DEVELOPMENT REVIEW COMMITTEE (DRC) COMMENT REPORT

PROJECT NAME: Millennium Townhomes III

CASE NUMBER: UDP-S22039

REQUEST: Site Plan Level II Review: Eight-Unit Townhouse
Development

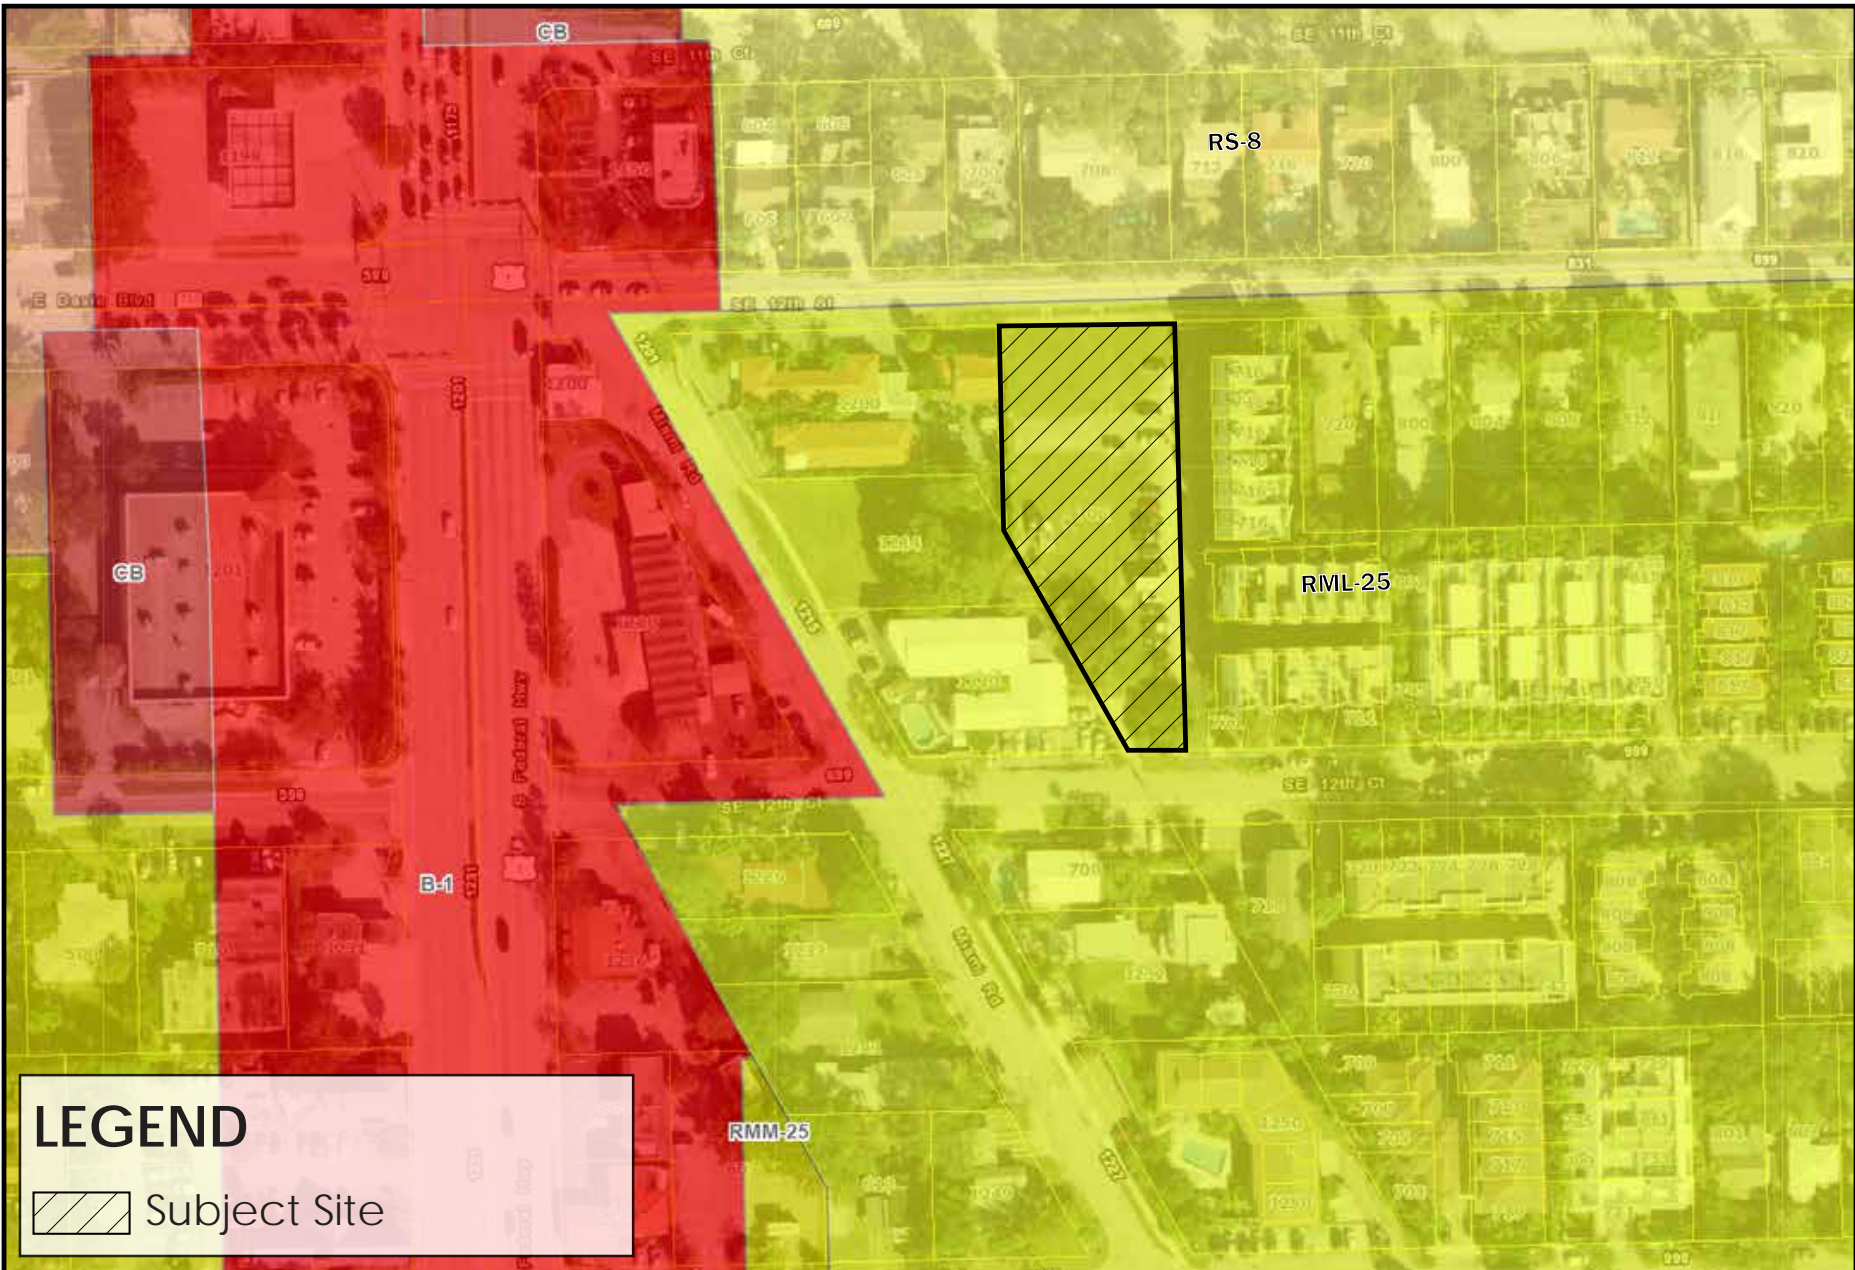
Discuss if proposed building overhangs are intended to encroach beyond Fee Simple lot boundaries, and within adjacent Common Areas.
